**PREFERRED PROJECT REPORT
(AMENDED)**

132-138 KILLEATON STREET, ST IVES

DECEMBER 2010

Figure 1: 3pm mid-winter shadow cast under original proposal

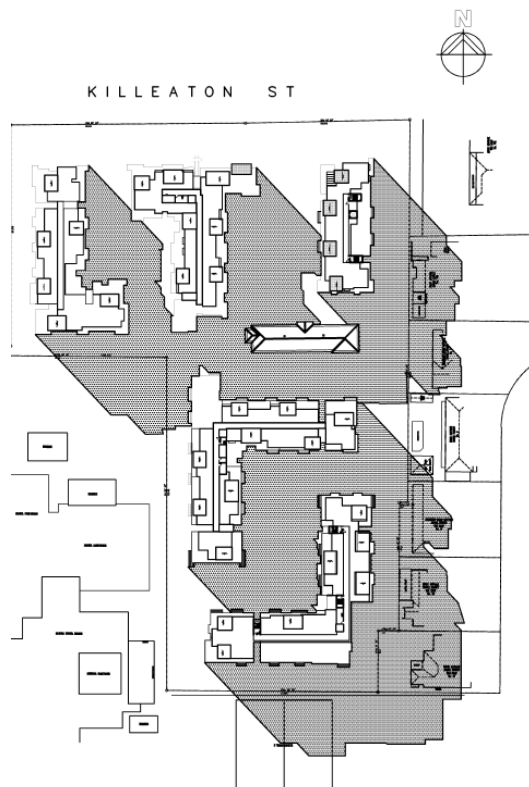
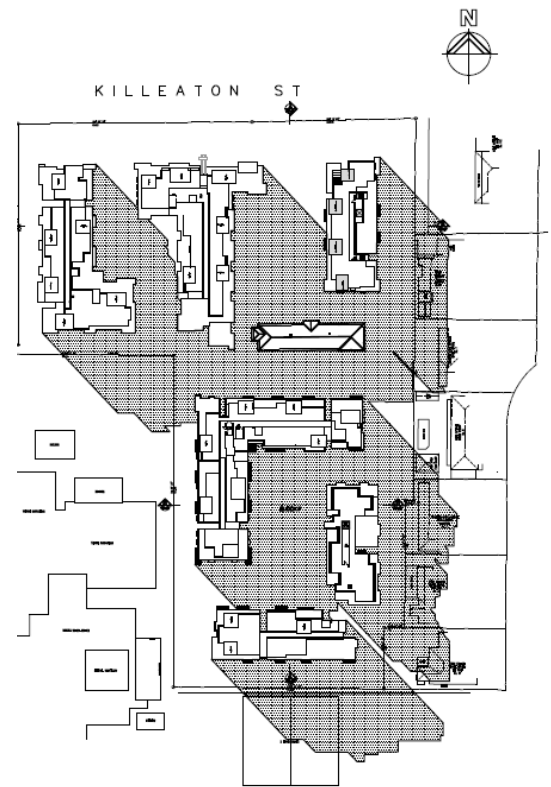
Overlooking and overshadowing

The proposal has been amended to address concerns raised by residents that adjoin the eastern side of the subject site. Buildings C and E have been reduced in height – details are provided in section 3.1. The reduced height of the buildings significantly reduces overlooking impacts and overshadowing impacts.

The amended architectural plan set at **Annexure 4** contains shadow diagrams that show the extent to which adjoining properties to the east are affected by shadow. The comparison mid-winter 3pm diagrams below show how significantly the shadow has been reduced by the proposed amendments.
